DA2016/017/02
22 November 2018

Access Compliance Report to accompany a

Development Address: 27-35 Punchbowl Road, Belfield.

Client: Gazcorp Pty Ltd c/o Olsson & Associates Architects

Accessible parking spaces allocated to Basement 1 is shown above (total of 15 accessible)

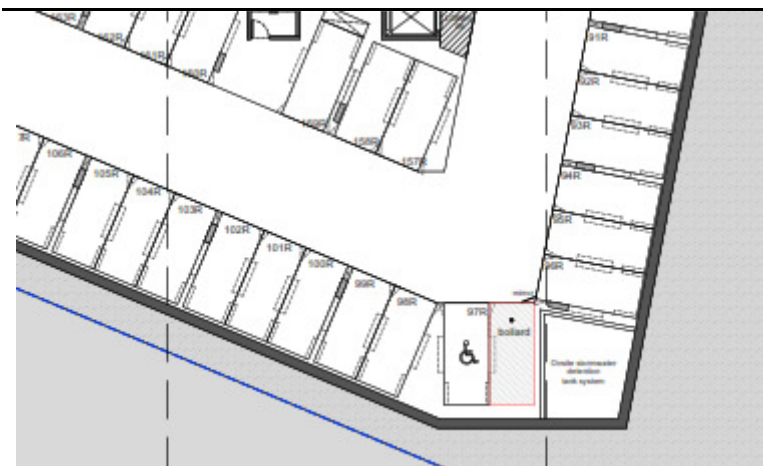
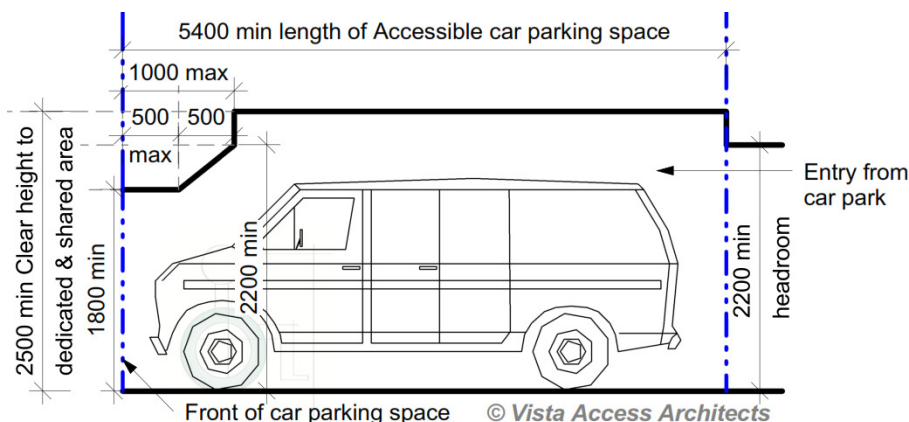
Compliance Comments	<p>Complies.</p> <p>Strathfield Council has previously approved 10% Adaptable units in the development. Development has total number of 115 units = 12 required Adaptable units.</p> <p>Therefore 12 accessible carparking spaces are required for the residential component. 12 Accessible car parking spaces have been provided in development. One accessible parking space is required to be allocated to each of the Adaptable units.</p> <p>Any additional accessible car parking spaces if provided are to be provided as visitor parking spaces</p> <p>Detailed features of the accessible/ adaptable parking spaces are to be verified at CC stage of works.</p>
Requirement	Class 5 - 1 space per 100 carparking spaces Class 6 - 1 space per 50 carparking spaces (up to 1000 spaces) and additional 1 space per additional 100 spaces provided
Compliance Comments	<p>Complies.</p> <p>Total number of Accessible parking spaces provided in the development = 1 for commercial component and 1 for retail component which complies with the requirement.</p> <p>Detailed features of the accessible parking space to be verified at CC stage of works.</p>

Accessible parking to basement 2 shown above (total of 1 accessible)

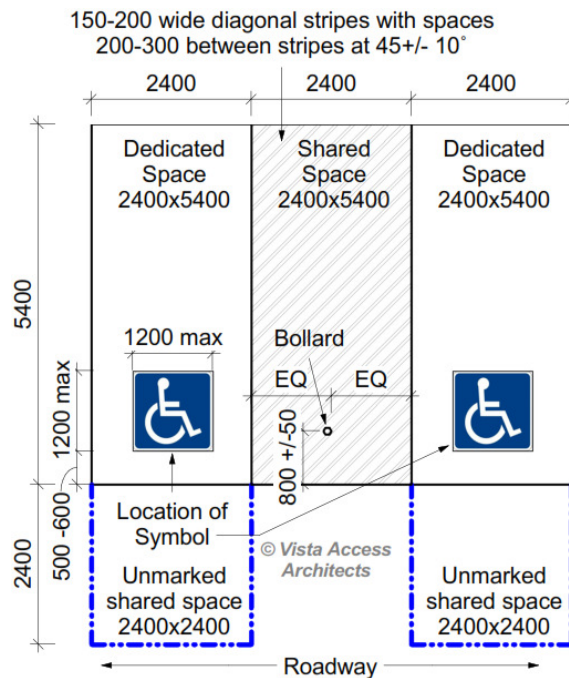
The Accessible parking, shared zones, linemarking and bollards to be as shown above.
Access symbol is not to be provided when spaces are allocated to Adaptable units.

ADAPTABLE UNITS F101 / F201 / F301 / F401

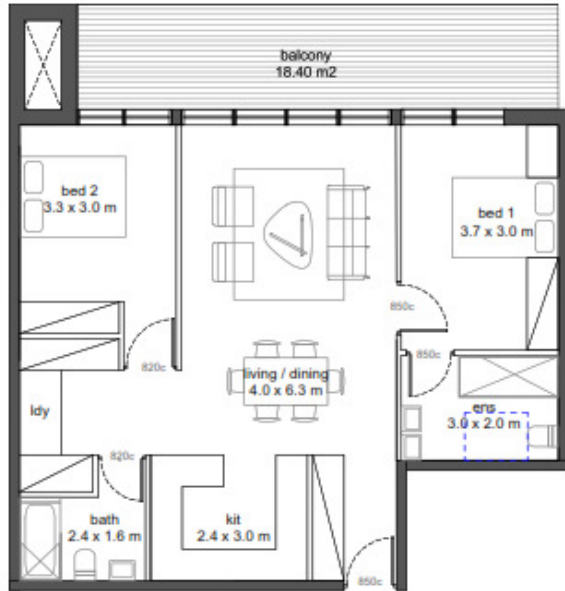
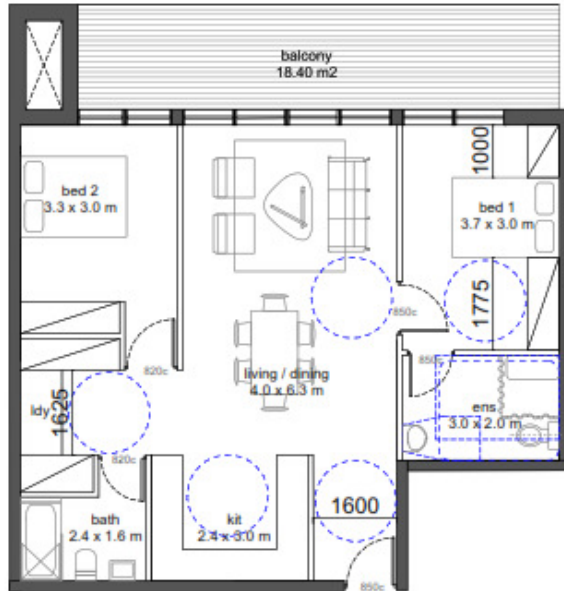
12 Adaptable units have been provided. The units designated as adaptable are units D401/ D501/ D601 / D701 / E201 / E301 / E401 / E501 / F101 / F201 / F301 / F401
